**TITLE:** Pelican 1650 Transport Case Design Refinements

**PRODUCTS AFFECTED:** Pelican's 1650 Protector™ Cases

**INTRODUCTION:** The 1650 Transport Case design has been modified (**Cases manufactured in Germany have yet to be modified**).

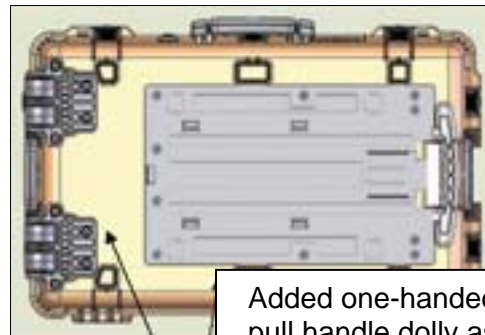
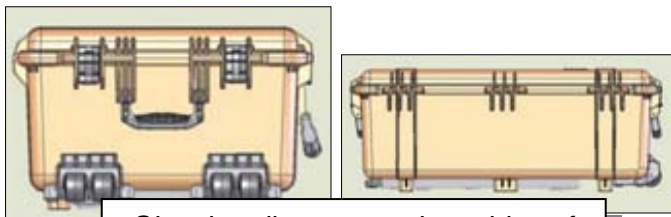
Added overmolded front and side handles

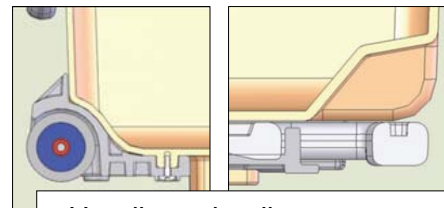
Added one-handed-action pull handle dolly assembly (Similar to 1640 the Transport Case)
